**SEQUOYAH NUCLEAR PLANT (SQN) RESPONSE TO REQUEST FOR  
ADDITIONAL INFORMATION (RAI) REGARDING UNIT 2 TECHNICAL  
SPECIFICATION CHANGE 06-06, PROBABILITY OF PRIOR CYCLE  
DETECTION (POPCD) (TAC NO. MD4110)**

Reference: NRC letter to TVA dated November 20, 2007,  
"Sequoyah Nuclear Plant, Unit 2 - Request for  
Additional Information Regarding Revised  
Probability of Prior Cycle Detection Model (TAC  
No. MD4110)"

#### RESPONSE TO REQUEST FOR ADDITIONAL INFORMATION (RAI) FOR SQN TECHNICAL SPECIFICATION (TS) CHANGE 06-06, PROBABILITY OF PRIOR CYCLE DETECTION (POPCD)

**Figure 5-1. Sequoyah-2 and Industry 7/8" POPCD above 1.0 Volt**

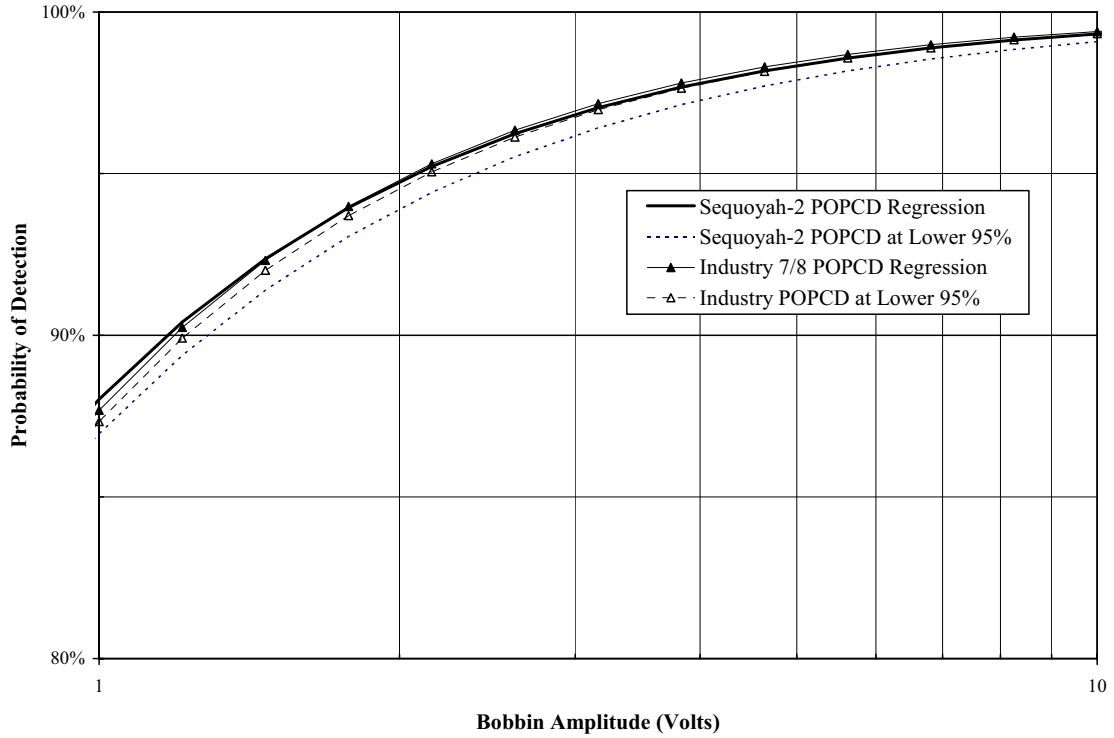
***In addition, please provide an enlarged view of the data above 1.0 volt in Figure 5.***

An enlarged view above 1.0 volt in Figure 5 is provided as Figure 5-1 (see page E1-30). The SQN-2 POPCD curve at the lower 95 percent is conservative relative to the industry curve while the nominal regression curves are nearly identical. The smaller number of data points in the SQN-2 POPCD data compared to the industry data lead to the larger uncertainties for the SQN-2 POPCD. However, the differences are small and have negligible influence on burst probability and leakage analyses.

Figure 8-1.

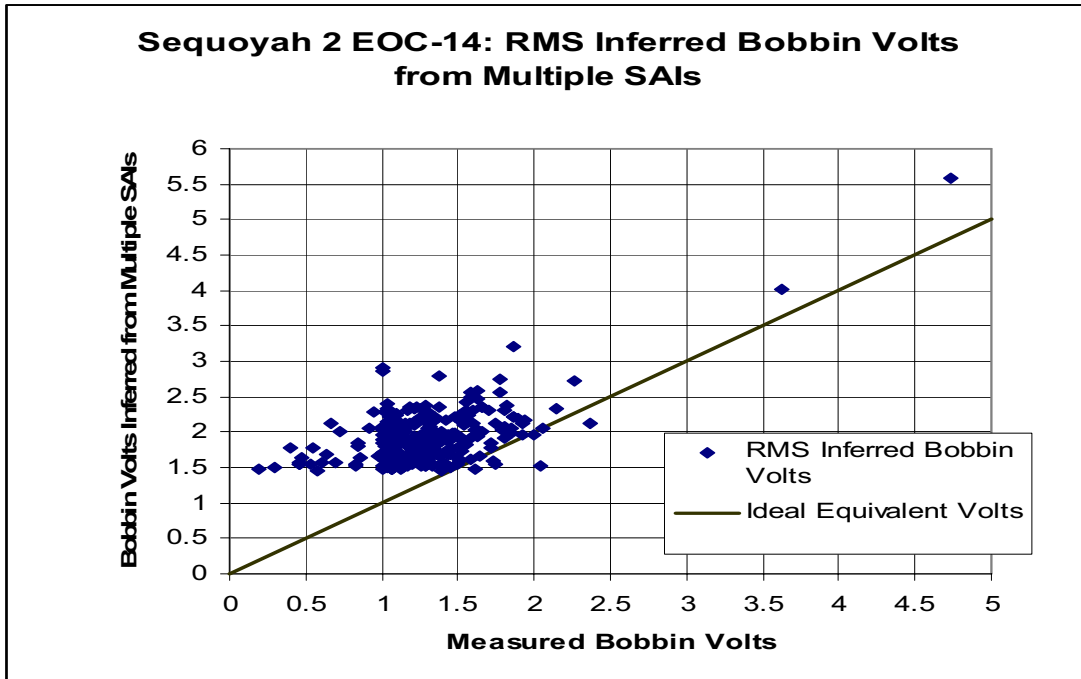
*On page E4-7, you indicated that data supporting the adequacy of using the square root sum of the squares method for determining the inferred bobbin voltage from multiple rotating probe indications at a tube support plate was provided by another utility (in an August 18, 2004 letter). Since this information*

***was specific to this utility, please provide a similar plot demonstrating that the approach is currently adequate for SQN-2 (future assessments will be provided in the 90-day report).***

Figure 8-1 (see page E1-31) shows the inferred bobbin voltage from multiple +Point indications compared to the measured bobbin voltages. The inferred bobbin volts are obtained as the square root of the sum of squares of the bobbin volts obtained for each +Point indication from the correlation of bobbin volts to +Point volts. It is seen that the inferred bobbin volts are conservative compared to the measured bobbin volts for nearly all measurements. The conservatism results from the relatively high bobbin volts obtained from the correlation with +Point volts as shown in Figure 8-2 (see page E1-31), which represents the correlation updated to include EOC-14 data. The polynomial fit to the 95 percent confidence on the mean regression line is used to infer the bobbin volts. It is seen that the bobbin volts inferred from the +Point volts is always greater than unity such that the multiple +Point indication correlation leads to bobbin volts greater than 1.5. Figure 8-2 is further discussed in RAI-9.

Figure 8-2.

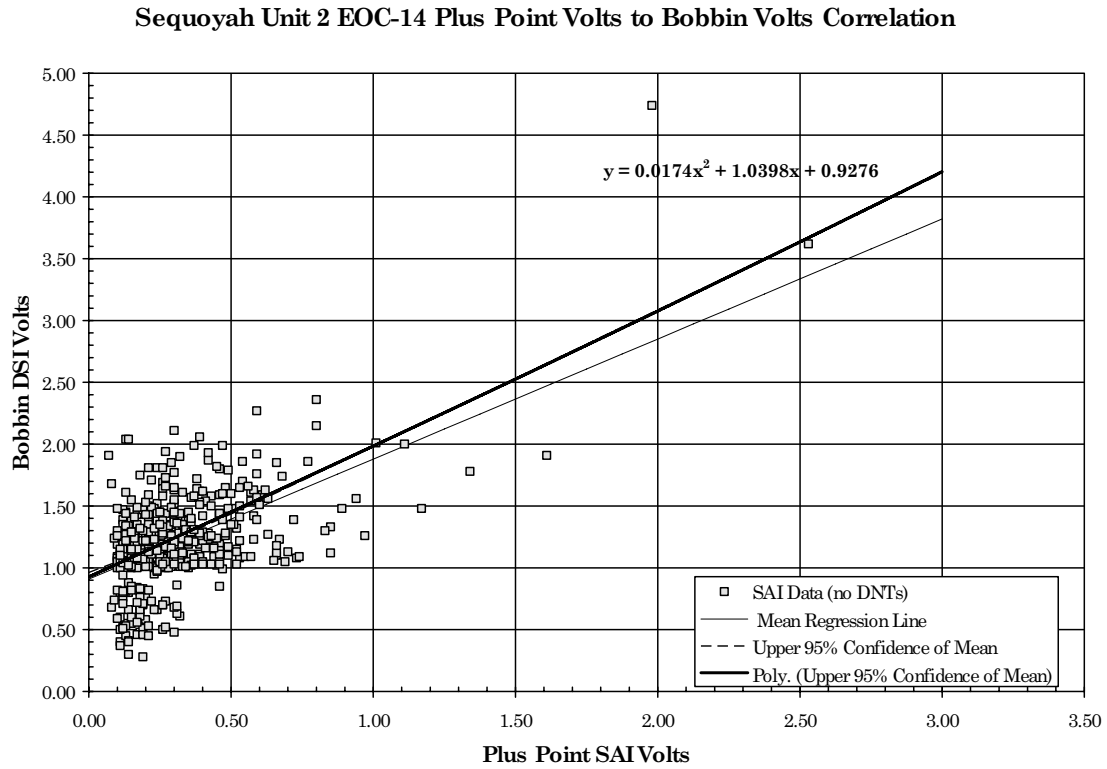
***Figure 2 provides a correlation for assigning an inferred bobbin voltage to indications detected only with a rotating probe. A similar curve is provided in Figure 3-13 of your March 20, 2007 letter, which submitted the SQN-2 Cycle 14 90-day SG report. Please discuss the differences in these curves. Please discuss if there have been significant changes in this correlation with time. If so, discuss whether a composite curve is more appropriate or whether a conservative lower bound to any single cycle data is appropriate. In addition, please confirm that there are no data from axially oriented outside diameter stress corrosion cracking indications not detectable by bobbin (AONDBs) such that an assessment of the adequacy of this correlation can currently be assessed. The staff notes that it appears that the prior practice was to plug AONDBs on detection (page E4-17).***

Figure 8-2 (see page E1-31) shows a revision of the submittal's Figure 2 bobbin to +Point volt correlation for SQN-2 EOC-14 data. The +Point data for this correlation includes the single axial indication (SAI) data from the EOC-14 inspection.

Upon approval for POPCD implementation, the 95 percent confidence on the mean bobbin to +Point voltage correlation will be applied to obtain inferred bobbin voltages consistent with Figure 2 of the transmittal and Figure 8-2 (see page E1-31) of this response. The adequacy of the correlation cannot be assessed since the prior practice was to plug the indications.

**Figure 16-1. POPCD for Sequoyah-2 Cycles 7-12 and Cycle 12 above 1.0 Volt**  
**Comparison of Sequoyah-2 EOC 7-12 and EOC 12 POPCD above 1.0 Volt**  
 Weighted Generalized Linear Model Loglogistic Solution

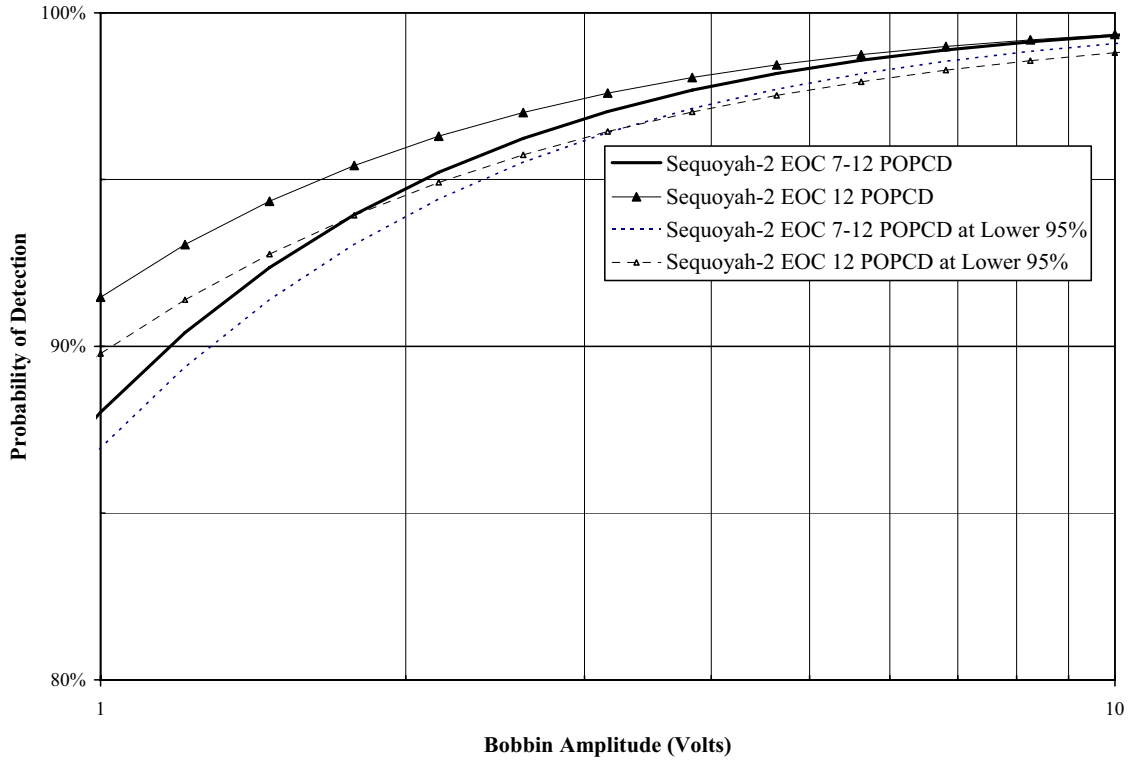
***Please provide an enlarged view of the data above 1.0 volt in Figure 4. In addition, please discuss what POPCD curve is required to be used in the assessments given that the POD above 1.0 volt for the cycle 12 data is less than the corresponding POD for the composite dataset.***

Figure 16-1 (see page E1-32) provides the requested data above 1.0 volt from Figure 4 of the transmittal.

On page E4-19 of TVA's January 12, 2007 transmittal, it is noted that the multi-cycle POPCD is considered more appropriate for future operational assessments than any one cycle of POPCD data. On page E4-23, first bullet, it is noted that differences between the multi-cycle POPCD and the last cycle should be assessed in the 90-day report relative to the potential for significant changes in detection capability. Recognizing the number of data points for any one cycle of POPCD is considered to be too small to control the expected POPCD for the next cycle, if there are "significant" negative trends in POPCD, appropriate adjustments will be made to POPCD to ensure reliable projections continue to be made. If there are "significant" negative trends in POPCD, other corrective actions may also be necessary (e.g., chemical cleaning to reduce noise, other actions to reduce noise in the ECT, . . .).

**Figure 19-1**

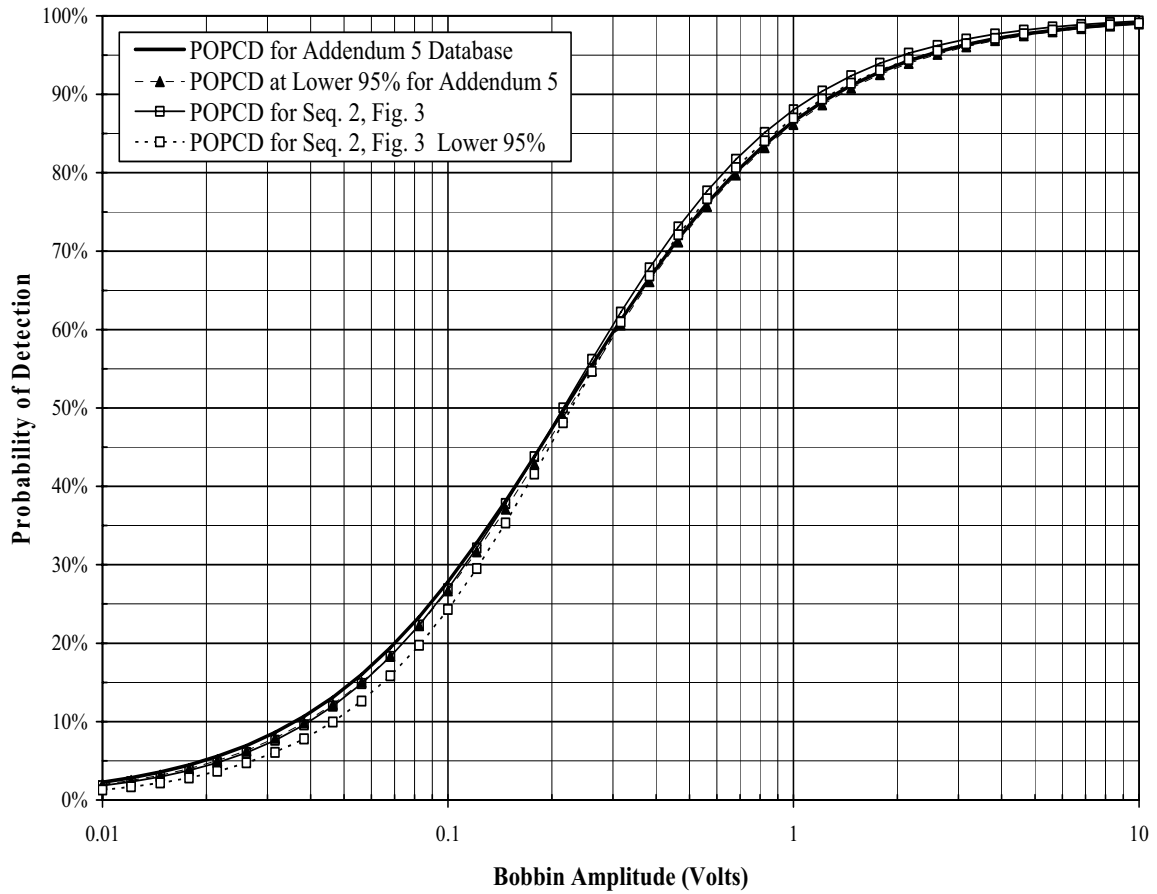
***You indicate that you will address POPCD uncertainties by either applying POPCD at the lower 95 percent confidence level or including an uncertainty analysis for POD in the operational assessment (Section 8.0 of your January 12, 2007 letter). Please clarify whether the "uncertainty analysis for POD in the operational assessment" is equivalent to the uncertainty analysis approved for use at Diablo Canyon (in their approval to use POPCD). If not, please clarify this statement.***

The Industry POPCD curve presented in Figure 1 and Figure 5 and expanded in Figure 5-1 (see page E1-30) is not the Addendum 5 curve used in the benchmark analyses. The Figure 1 curve is described in the submittal as "essentially the same as reported in Addendum 6." Later, Figure 5 curve (the same as Figure 1) is described as "industry POPCD updated to the time of the Sequoyah 2 POPCD submittal." The Addendum 5 curve is shown in Figure 19-1, and described as "Figure 19-1 shows the comparison of the industry Addendum 5 POPCD with the SQN-2 POPCD. It is seen that

Figure 23-1

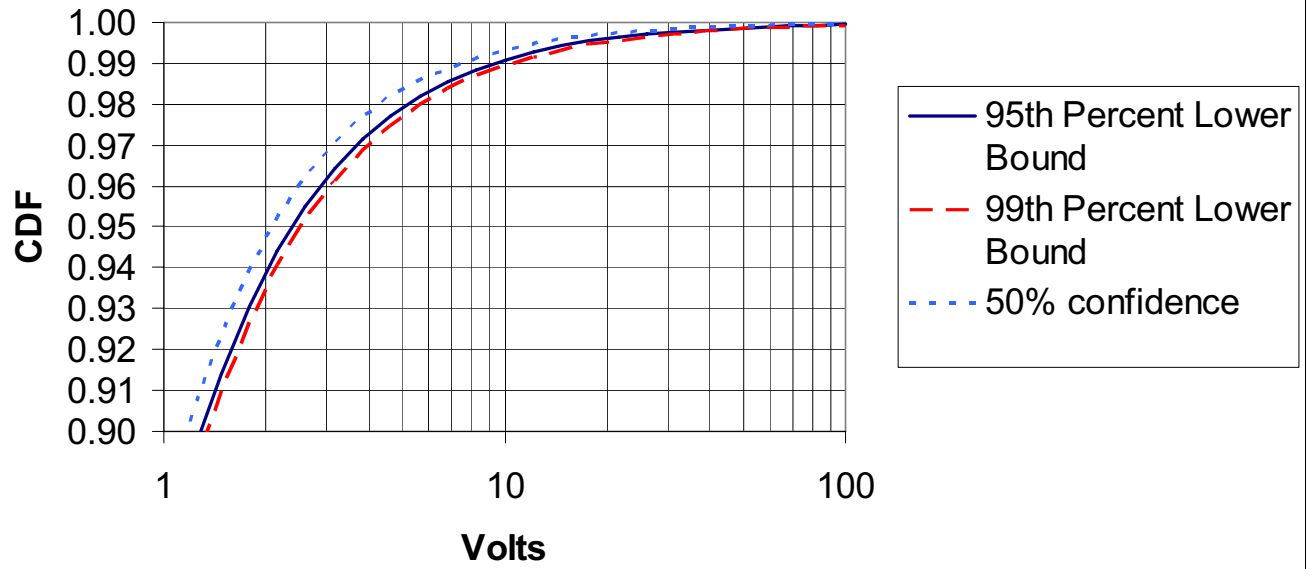
***In addition, since the POPCD curve is used to calculate the probability of burst under steam line break conditions and the amount of leakage under steam line break conditions, it would appear that an assessment of the adequacy of using the lower 95 percent confidence level to address uncertainty (rather than the Monte Carlo approach approved for use at Diablo Canyon) would be to evaluate the effects of the different approach for modeling uncertainty in the POPCD curves on the structural and leakage integrity of the SG tubes. Please provide this assessment.***

In order to illustrate the uncertainties in the SQN-2 POPCD, Figure 23-1 (see page E1-34) shows the POPCD curves for the 50 percent confidence, the 95<sup>th</sup> percentile lower bound, and the 99<sup>th</sup> percentile lower bound POPCD for volts greater than 1 volt. It is seen that the curves are quite close. To assess the effect of these differences on probability of burst and leakage, the SG 4 example case which was run with 1 million trials is rerun with the 50 percent confidence and with the 99-percent lower-bound POPCD curves. The results are shown in Table 23-1 (see page E1-28). It is seen that compared to the 50 percent confidence POPCD, the 95 percent confidence POPCD results in a slight increase in the number of indications, leak rate and POB. However, compared to the 95 percent confidence POPCD, the 99 percent confidence POPCD results in a small increase in the number of indications, no increase in the leak rate, and a small decrease in the POB. From these results, it is seen that the POPCD uncertainties have a negligible effect on the burst and leakage predictions; and therefore, a refinement in the methodology to include the POPCD uncertainties in the Monte Carlo process is unwarranted.

Compared to the PWSCC ARC that was implemented for Diablo Canyon, the application of a 95<sup>th</sup> percentile POPCD is very different. For example, consider a 3-volt indication and assume the indication was plugged. As seen in Figure 23-1 (see page E1-34), the mean POPCD is 0.97, and the 95<sup>th</sup> percentile is 0.96. A POD of 0.97 in the ARC analysis means that for every 100 Monte Carlo trials of the population in the SG, there will be 3 indications that are to be included in the analysis. If uncertainties are applied (symmetric about the mean), sometimes the POD will be a little higher and sometimes it will be a little lower. At the end of the analysis, the number of 3-volt indications considered will be 3/100 times the number of Monte Carlo trials.
